***MODIFICATION REQUEST:  
Honeysuckle Central  
Mixed Use Development  
Honeysuckle Drive, Newcastle  
(MP08\_0043 MOD 1)***

Director-General's  
Environmental Assessment Report  
Section 75W of the  
*Environmental Planning and Assessment Act 1979*

April 2012

**Figure 4: Proposed Modified Ground Floor Plan / Site Plan**

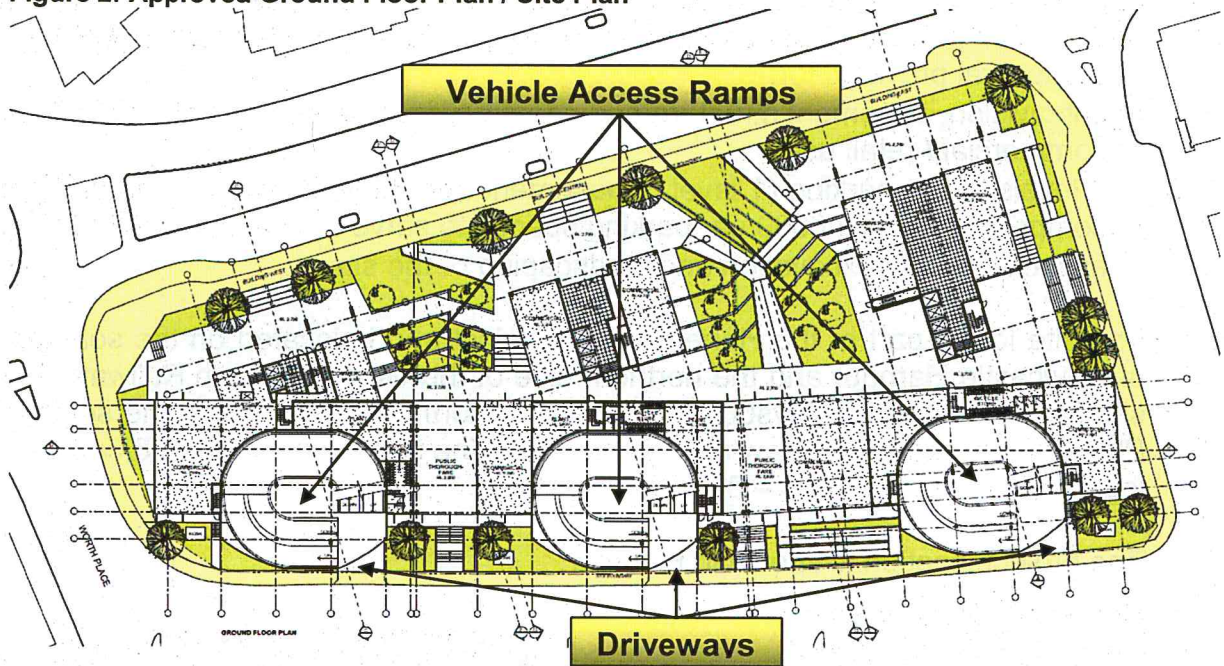
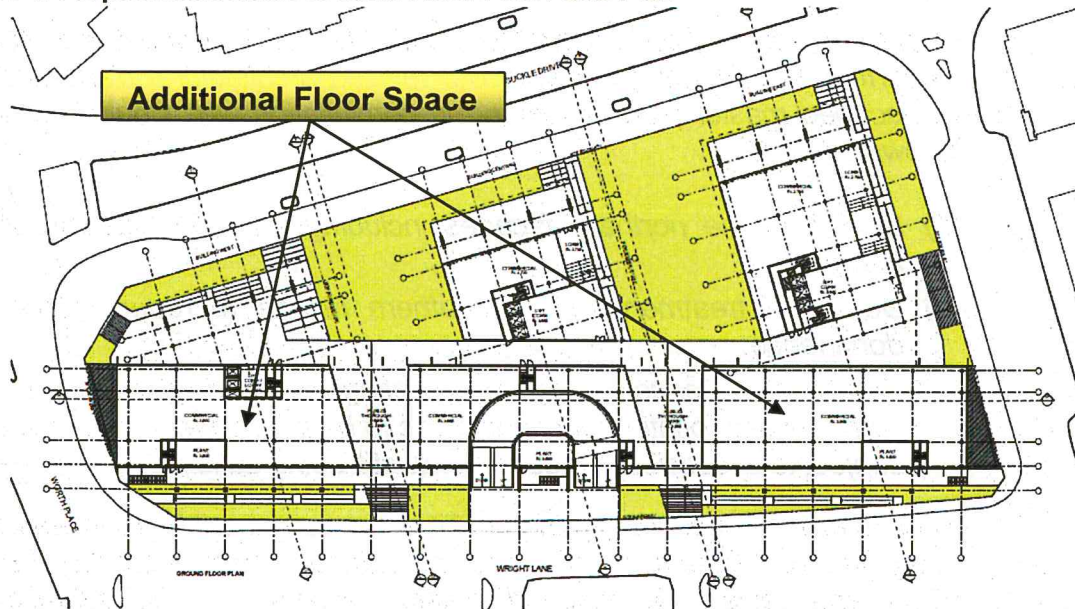
The removal of two of the three approved car park driveways from the south elevation (see Figure 8) is intended to improve the urban design of the building and provide for additional deep soil zone and soft landscaping areas. Additionally, the removal of the vehicle access ramps to the east and west towers has increased the opportunity for ground floor commercial / retail space which will improve activation along the southern elevation of the development.

**Figure 5: Original North Elevation**

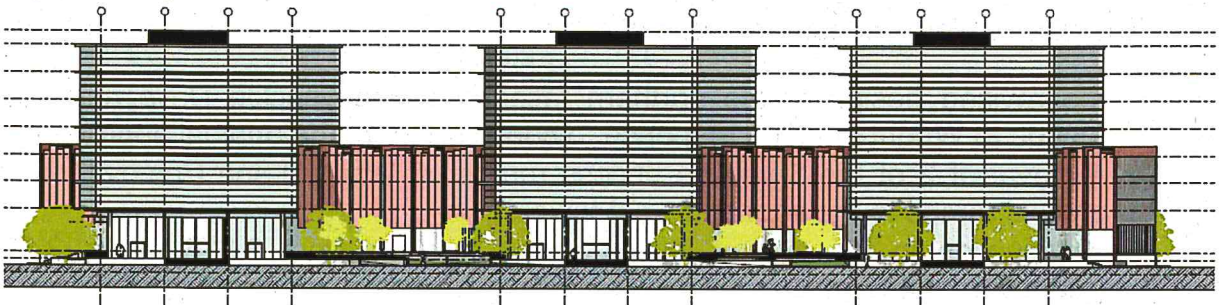
The modification request seeks approval of design revisions to the northern and southern façades of the building in response to the abovementioned condition. The proposed revised design of the northern façade to Honeysuckle Drive includes further articulation of the splayed glass facades by introducing slab projections to each floor, angled vertical splits and introducing colour panel break ups. The additional design features have a number of protruding and recessed elements which add light and shade to the facades. Additionally, the position of the protruding and recessed elements and architectural features is different for each building facade and is intended to provide variety to each building fronting Honeysuckle Drive. The original northern facade and proposed modified northern facade is shown in Figures 9 and 10.

- the introduction of slab projections, and colour break-ups and the addition of light and shade on the splayed glass northern façades has broken up the built form and increased the articulation of each building;

- the positioning of the new design elements is different on each building and has introduced some variety and individual identity to each building, whilst maintaining the overall consistency in the design;

The department has considered the proposed modified design of the northern and southern facades on merit, and considers that it satisfactorily responds to the intent of condition B6 for the following reasons:

Figure 8: Proposed Modified South Elevation

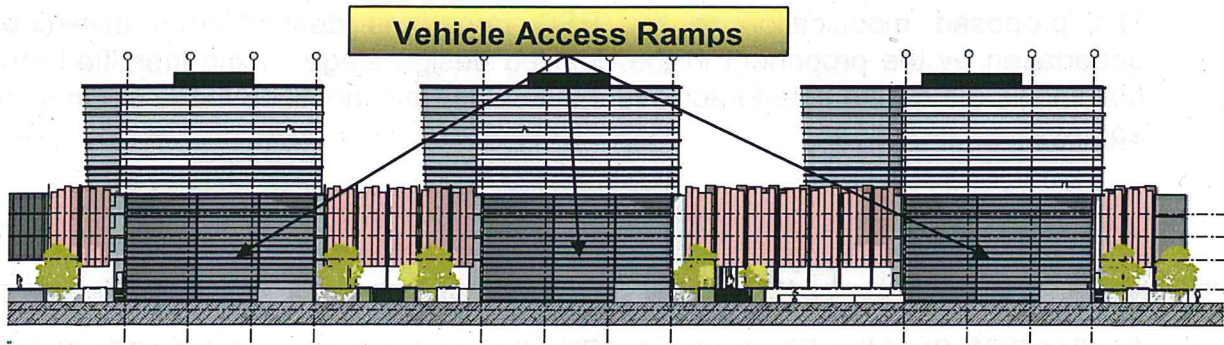
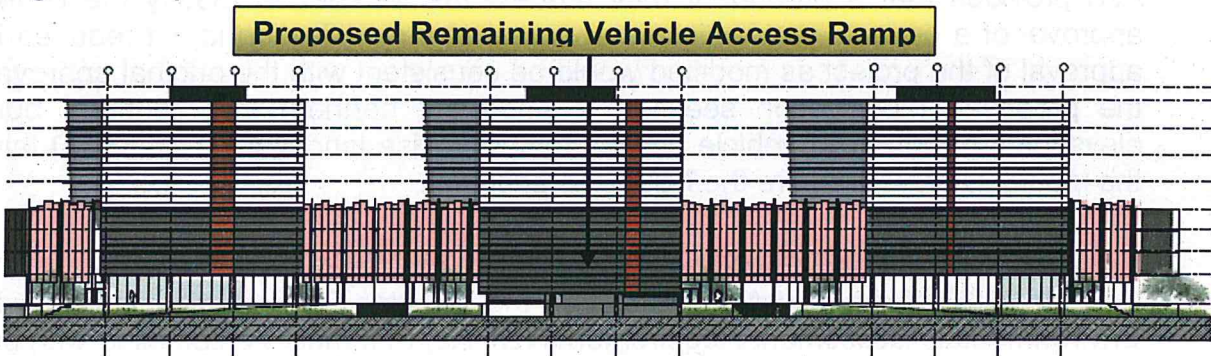
- the removal of car park ramps and car park screening on the southern façade and its replacement with glazing and commercial floor space has changed the composition of the southern façade and significantly reduced the visual bulk and dominance of the building;

- the introduction of design elements to the southern façade, such as articulated screens, angled walls and colour break-ups has also further enhanced the presentation of the building from the south;

**Figure 13: Original Landscape Masterplan**

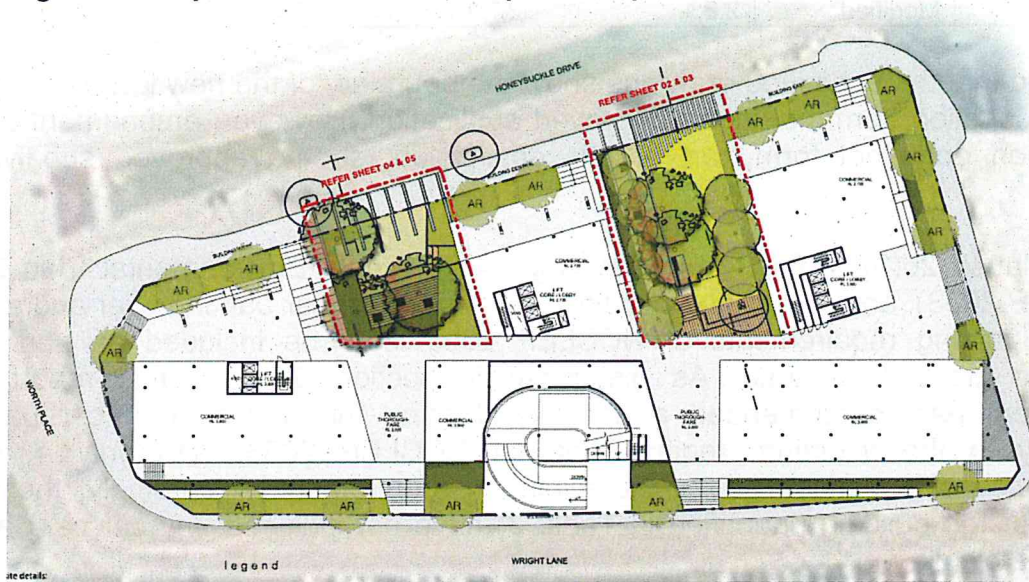
The modification request seeks approval of a revised landscape masterplan in response to the abovementioned condition. The revised landscape masterplan includes two 'pocket parks' off Honeysuckle Drive which provide increased areas for deep soil planting between each of the interconnected buildings. A breakdown comparison of the original landscape masterplan against the revised landscape masterplan is provided in Table 2 and Figure 13 and 14.

- deep soil planting areas of the development have increased by 508 m<sup>2</sup> under the revised landscape masterplan;
- the extensive landscaped voids or 'pocket parks' have accommodated larger deep soil tree plantings such as *Jacaranda mimosifolia* (Jacaranda) and *Delonix regia* (Poinciana), which will provide an alternative landscape element when viewed from Honeysuckle Drive;
- paving and hard stand spaces have decreased by 58 m<sup>2</sup> under the revised landscape masterplan; and

- the revised landscape masterplan incorporates additional vegetation planting, including a series of *Agathis robusta* (Kauri Pine ) plantings along the Honeysuckle Drive site boundary, as well as the eastern and southern site boundaries, which will assist in providing an added vegetation buffer and reducing the apparent scale of the development from surrounding vantage points.

The department considers that the revised landscape masterplan satisfactorily addresses the landscape requirements of condition B6 for the following reasons:

Figure 15: Proposed Modified Ground Floor

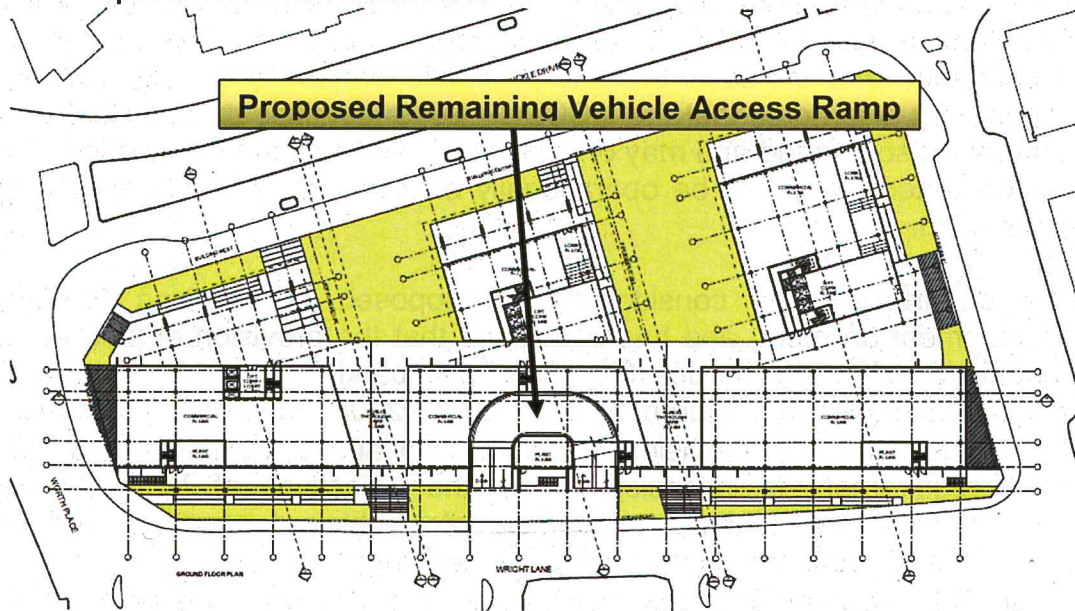
Newcastle City Council's (NCC) submission supported the reduction in vehicular access points to the site due to the resultant improvements in pedestrian movement and safety. However, NCC's submission identified that reverting to one access will require that appropriate rights of carriageway be applied to the car parking areas to ensure all vehicles have a legal right to access across adjacent private property to reach their designated parking space. In this regard, NCC recommended that condition B9 of the original project approval be amended to include the following additional provision:

The department notes that the maximum recommended lane capacity for the site entry is 400 vehicles per lane per hour where the entry point includes a card reader. When considering the car parking demand of the development is 374 (under NCCLEP 2008), and given the broad range of start times for various commercial

uses which will occupy the buildings, the department is satisfied that the single access point will provide sufficient vehicular access to the car parking areas.

The department also considers that the removal of the two vehicle access points results in an improved design outcome through increased activation at the pedestrian scale and improved pedestrian safety. Additionally, in accordance with NCC's recommendation, the department has recommended an additional condition requiring the proponent to obtain the necessary covenant to facilitate reciprocal rights of way from the central entry to the car parking areas for each of the buildings.
